**Champlain Hudson Power Express (“CHPE”)
Environmental Management & Construction Plan
Notice of Major Change**

Project: Champlain Hudson Power Express

Notice Number: CN 063

Drawing References: Segment 6 (Package 4A): C-121, C-122, C-123, C-124, C-125, C-304B, C-304B.1, C-304C, C-304C.1, C-411, C-412, C-413

Segment 6 (Package 4A)
**EM&CP Appendix E Updates to
Excursion S6-P4A#5 GIS Exhibit**

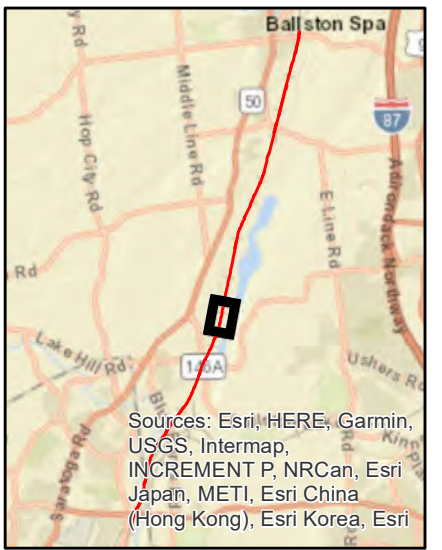
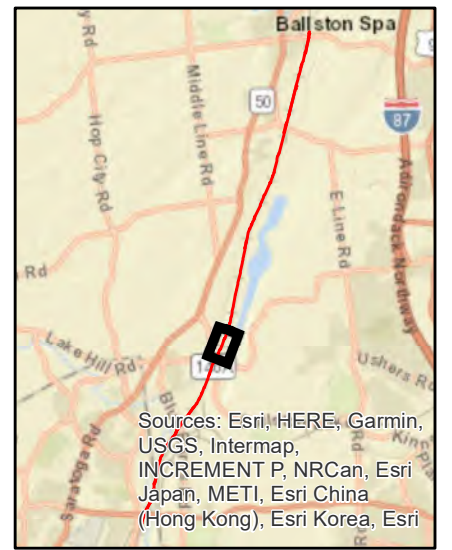
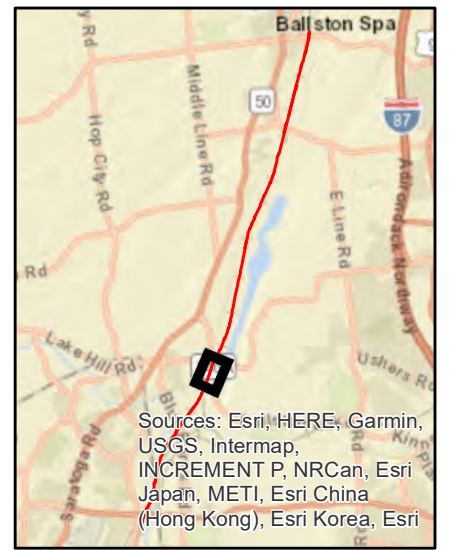
The length of the excursion is approximately 30,933 linear feet and approximately 5,093 feet is HDD below grade with no surface disturbance. The proposed excursion occurs approximately 220 linear feet west of the ADZ at the farthest point.

In addition to the previously provided justification, this change is justified as a means to reduce potential conflicts with collocated infrastructure, as well as impacts to wetlands, the host community, public lands and the traveling public/local roadways .

PERMIT DRAWING NO.
N/A
DRAWING NO.
C-121

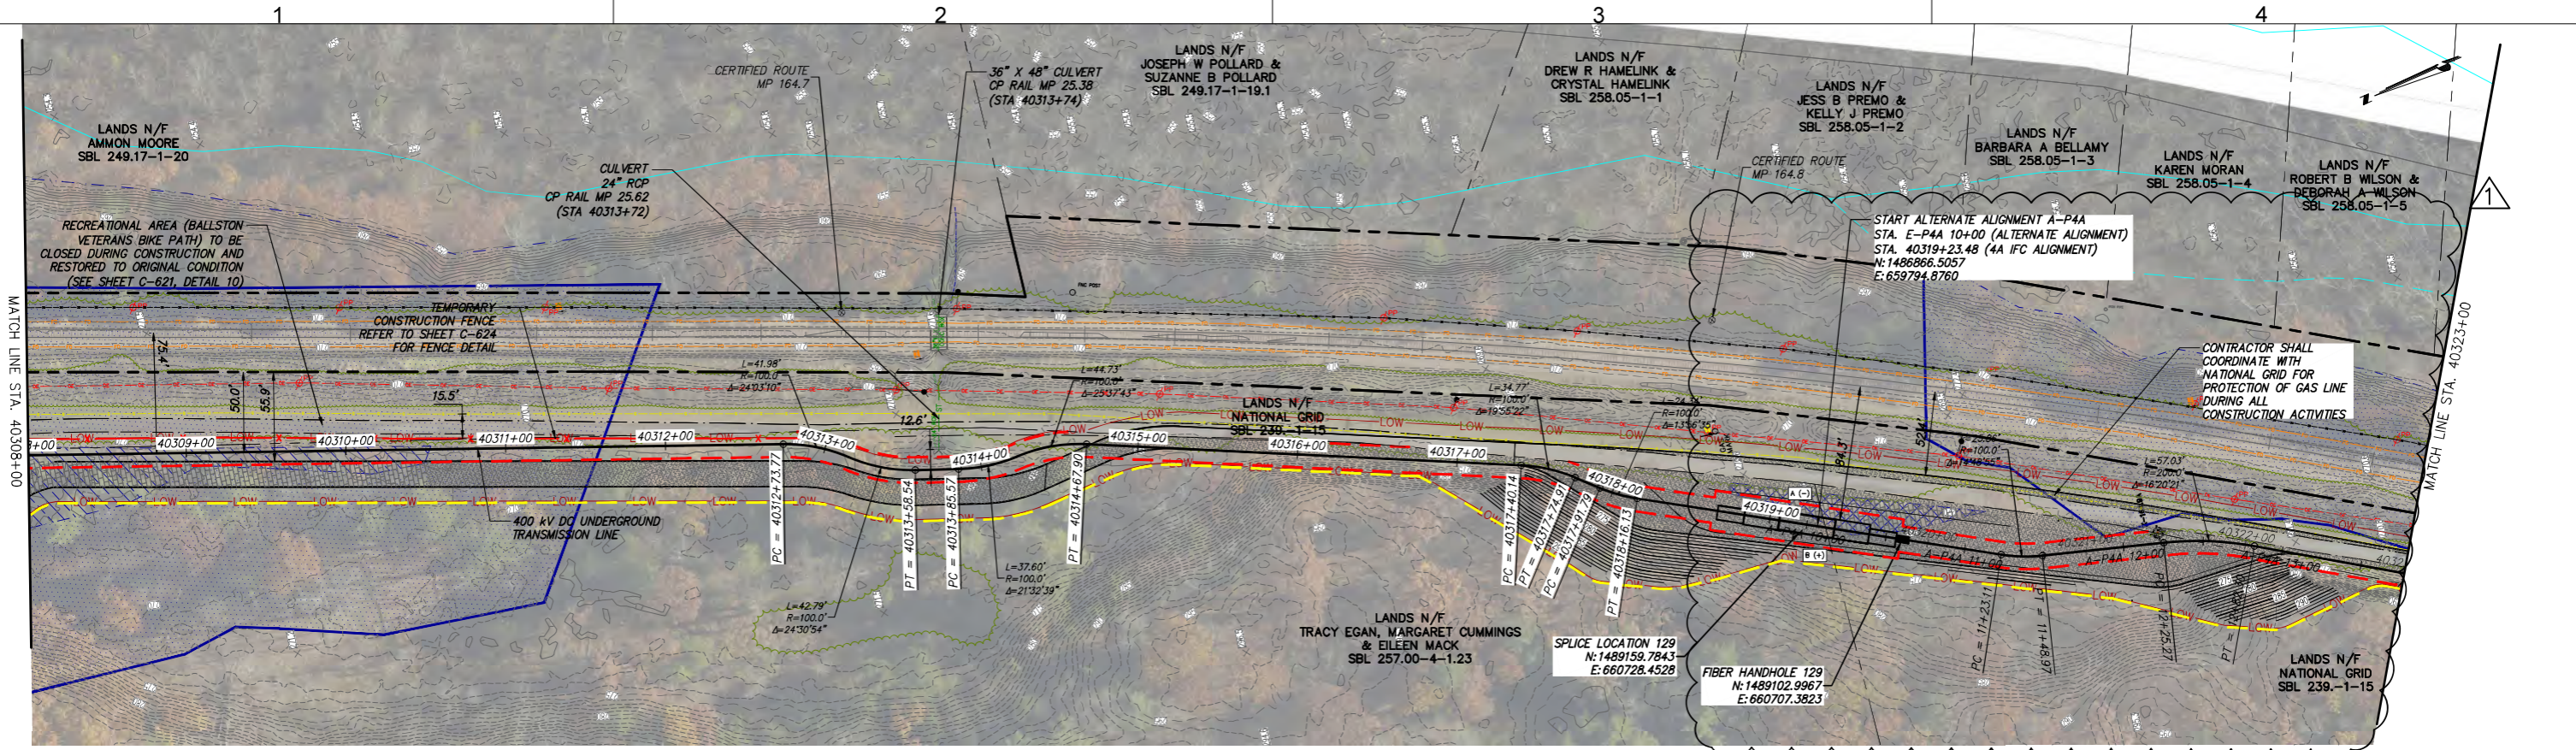
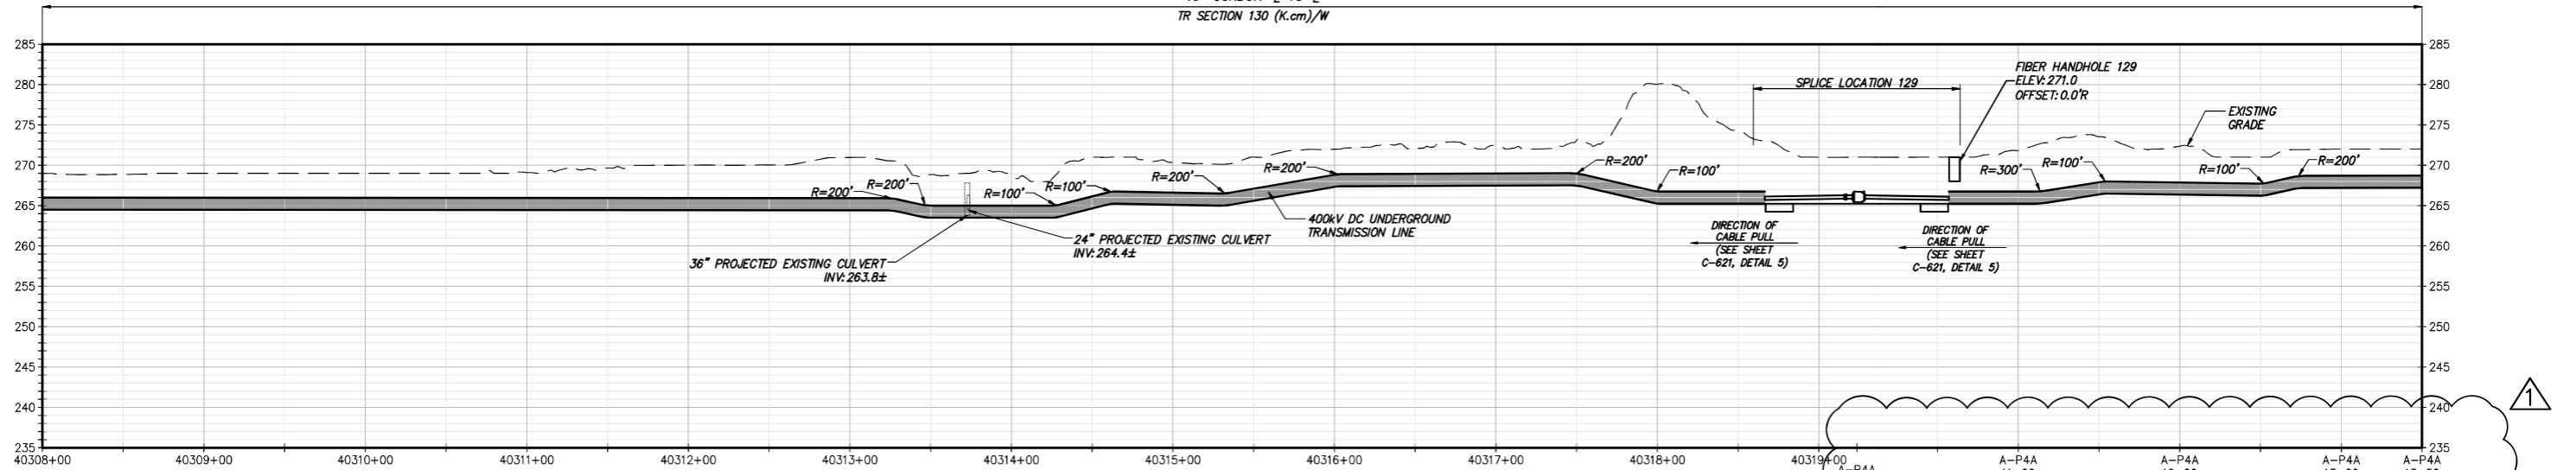
EM&CP Appendix C - Plan Sheet Updates				
Seg	Sheet	Rev No	Revision Description	Summary
6	C-121	1	NDC-0042_Alignment Adjustment at Fireman's Lane	Nominal change only. Splice 130 was shifted (C-123), so new continuous stationing was established back to Splice 129.
6	C-122	1	NDC-0042_Alignment Adjustment at Fireman's Lane	Nominal change only. Splice 130 was shifted (C-123), so new continuous stationing was established back to Splice 129.
6	C-123	1	NDC-0042_Alignment Adjustment at Fireman's Lane	Shift of Splice location 130. Added HDD 57B. Alignment and LOW adjustments to support.
6	C-124	1	NDC-0042_Alignment Adjustment at Fireman's Lane	Added HDD 57B. Alignment and LOW adjustments to support.
6	C-125	2	NDC-0042_Alignment Adjustment For Fireman's Lane	Added HDD 57B. Alignment and LOW adjustments to support.
6	C-304B	0	Issued for Construction: NDC-0042	New HDD: 57B.
6	C-304B.1	0	Issued for Construction: NDC-0042	New HDD: 57B.

PERMIT DRAWING NO.	N/A
DRAWING NO.	C-125

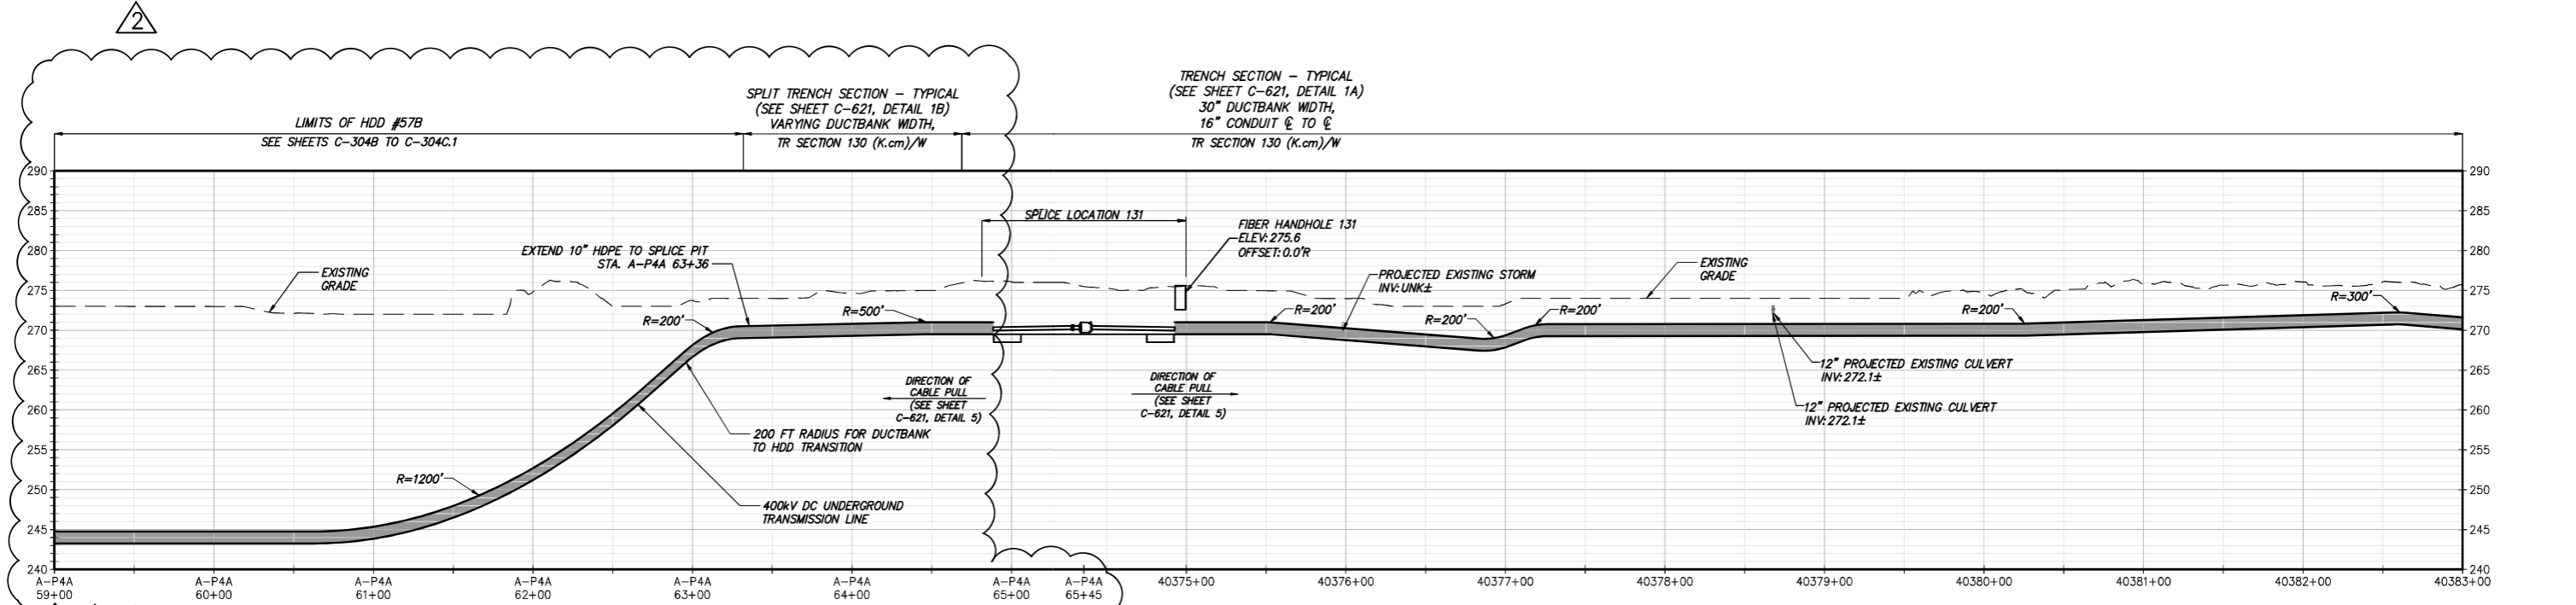
6	C-304C	0	Issued for Construction: NDC-0042	New HDD: 57B.
6	C-304C.1	0	Issued for Construction: NDC-0042	New HDD: 57B.
6	C-411	1	NDC-0042_Alignment Adjustment For Fireman's Lane	Created station equation to allow shift of splice 130. Nominal change only.
6	C-412	1	NDC-0042_Alignment Adjustment For Fireman's Lane	ESC updates based on revised alignment/LOW.
6	C-413	2	NDC-0042_Alignment Adjustment For Fireman's Lane	ESC updates based on revised alignment/LOW.
